Access Compliance Report

Public Rights-of-Way

Intersection ID: 48428	Main Street: ROUSAY_DR	Cross Street: DURNES DR	Location: NE
ADA ID: 0BEF8C1CC386	Ramp Type: PerpDiag	Initial Pass/Fail: Fail	Overall Compliance: No
		Severity Score: 12.5

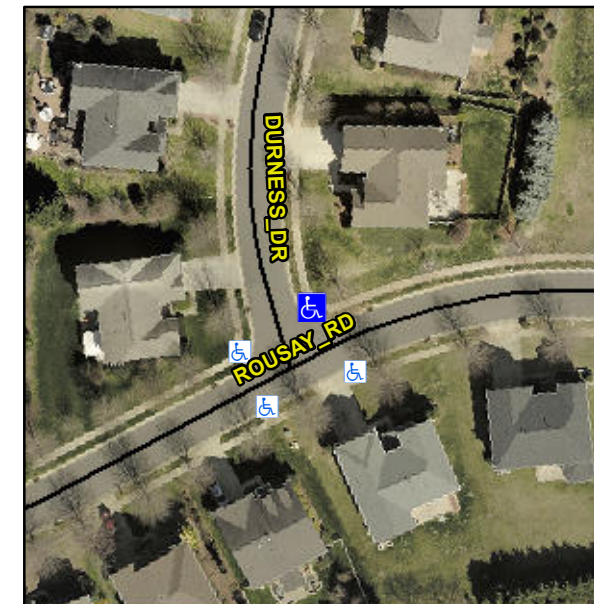
R304.5.3

Compliance	Description	Data	Compliance	Description	Data
N/A	Ramp Length (in)	47.0	Yes	Ramp Slope (%)	7.8
Yes	Ramp Width (in)	48.0	No	Ramp XSlope (%)	6.5
N/A	Flare Type LT	N/A	N/A	Flare Type RT	N/A
N/A	Flare Slope LT (%)	N/A	N/A	Flare Slope RT (%)	N/A
N/A	Flare Traversable LT?	N/A	N/A	Flare Traversable RT?	N/A
N/A	Landing Length (in)	N/A	N/A	DWS Provided?	N/A
N/A	Landing Width (in)	N/A	N/A	DWS Contrast?	N/A
N/A	Landing Slope (%)	N/A	N/A	DWS Length (in)	N/A
N/A	Landing X Slope (%)	N/A	N/A	DWS Full Width?	N/A
N/A	Landing Curb? (Y/N)	N/A	N/A	DWS Offset (in)	N/A
N/A	Shared Landing?	N/A			
N/A	Gutter Ponding?	N/A	N/A	Gutter Slope (%)	N/A
N/A	Gutter Lip Ht (in)	N/A	N/A	Gutter X Slope (%)	N/A
N/A	Painted X Walk1?	No	N/A	Painted X Walk2?	No
	X Walk 1 Direction	To SW		X Walk 2 Direction	To SE
N/A	X Walk 1 Width (in)	N/A	N/A	X Walk 2 Width (in)	N/A
	X Walk 1 Slope (%)	2.4		X Walk 2 Slope (%)	1.3
	X Walk 1 X Slope (%)	3.8		X Walk 2 X Slope (%)	4.0

Remove & Replace Curb Ramp With Two New Directional Ramps or Equivalent.
